Project	<b>IEEE 802.16 Broadband Wireless Access Working Group</b> < <a href="http://ieee802.org/16">http://ieee802.org/16</a> >	
Title	<b>Consolidation of Uncoordinated Coexistence Mechanisms</b>	
Date Submitted	<b>2007-07-09</b>	
Source(s)	Ken Stanwood NextWave Wireless	Voice: +1 858 480 3327 E-mail: <a href="mailto:kstanwood@cygnuscom.com">kstanwood@cygnuscom.com</a>
Re:	IEEE 80216-07/013 Task Group Review of P802.16h/D2b	
Abstract	Editorial instructions for consolidating mechanisms for uncoordinated coexistence into a single place in the document.	
Purpose	To avoid the confusion caused by having related mechanisms distributed throughout the document.	
Notice	<i>This document does not represent the agreed views of the IEEE 802.16 Working Group or any of its subgroups.</i> It represents only the views of the participants listed in the "Source(s)" field above. It is offered as a basis for discussion. It is not binding on the contributor(s), who reserve(s) the right to add, amend or withdraw material contained herein.

# Consolidation of Uncoordinated Coexistence Mechanisms

This document provides changes to IEEE P802.16h/D2b [1].

**Figure 1—Basic four frame repetitive sequence**

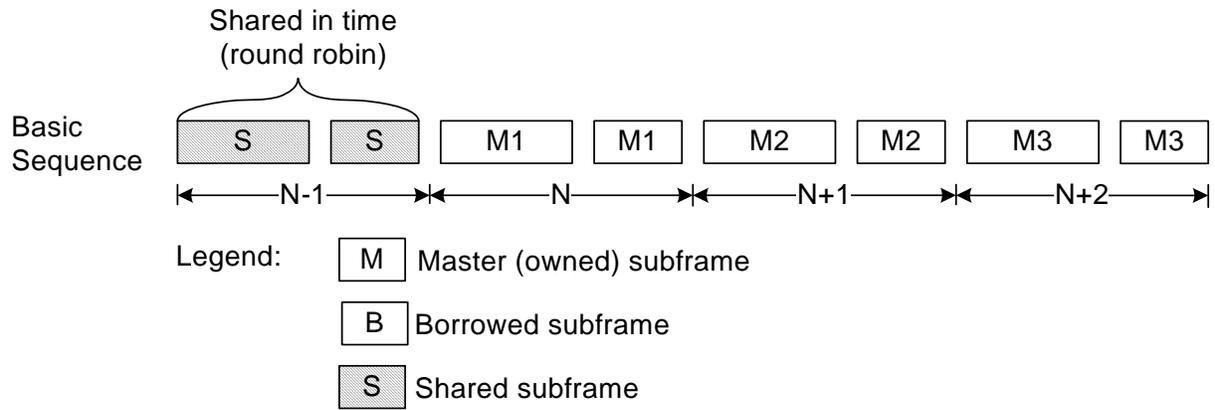
When all systems attempting to coexist on the same channel are 802.16 systems, the end result after all three systems have entered the channel is a four frame sequence of frame usage as shown in Figure h 1. This is a simplified version

[of Figure h25 with the simplification being necessary since the uncoordinated systems cannot communicate with each other regarding interference and power levels.](#)

**Figure 2—First 802.16 System Claiming Slot 1**

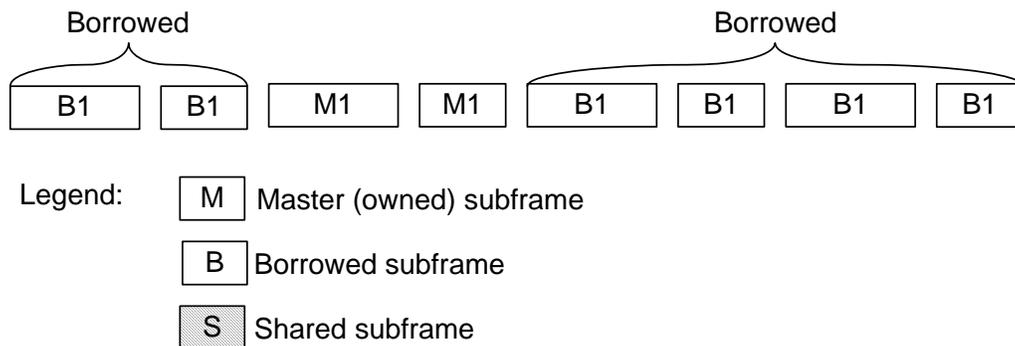
[The result of the first system claiming slot 1 of the repetitive sequence is shown in Figure h 2.](#)

**Figure 3—Second 802.16 System Claiming Slot 2**

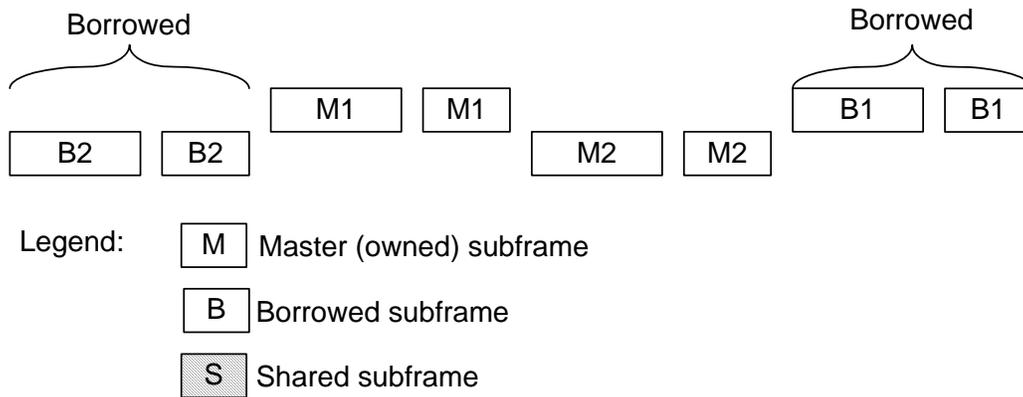
[The result after a second system has claimed slot 2 is shown in Figure h 3.](#)

**Figure h10—LBT**

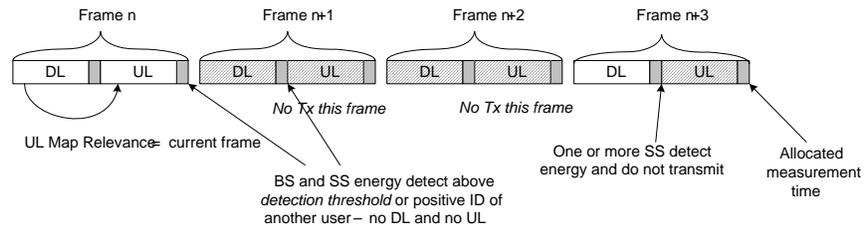
When attempting to coexist with certain non-802.16 users of non-exclusively assigned or non-exclusively licensed bands, EQPs may not be sufficient. In these cases, a LBT protocol must be used. In such bands, the BS shall operate with a UL-MAP relevance of the current frame. This allows the DL and UL subframes to be logically viewed as a single "packet" of constant duration equal to the frame duration. The BS shall periodically allocate ~~part of the DL sub-frame as an opportunity~~ opportunities for an SS to measure and report on the current state of the channel, and provide input to the LBT protocol. An Extended Channel Measurement IE (see for example sub clause 8.4.5.3.5) may be used, ~~along with a gap in DL transmission,~~ to provide such an opportunity. In a similar way in the gap between the UL and DL subframes, as close to time to transmit the DL as possible, the BS shall ~~part of the UL subframe may be reserved from SS transmission for the BS to~~ make measurements on the current state of the channel ~~and update the LBT protocol accordingly.~~ Given that the LBT protocol detects energy above the defined threshold then no transmission will take place in the succeeding subframe. ~~In the event there is no downlink transmissions then the SS will apply the last received DL MAP/UL MAP over the period of no transmission.~~ The use of the LBT protocol shall recognize appropriate use of the Lost DL/UL MAP Interval parameter in table 342. Transmission recommences when energy levels drop below the threshold level. Due to the fact that there may be no time to signal an energy detection event then a BS or SS shall reliable reliably handle the absence of a subframe where it was previously scheduled by the DL or UL-MAP. An example of this arrangement is given in *Figure h 10*. ~~This time period~~ The frame in which

[the system refrained from transmitting](#) shall be used to sense other non-802.16 systems. The minimum duration is 4 us. Specific implementation of this protocol is not specified and is left for vendor differentiation. Use of LBT shall not eliminate any requirements for other measurement and reporting that may be required for operation in a particular mode or band. Use of listen-before-talk shall not eliminate any requirement for use of EQPs. [However, refraining from transmitting during a frame due to energy detection during the LBT “listen” period shall count towards fulfilling the quite percentage of the aEQP duty cycle.](#)
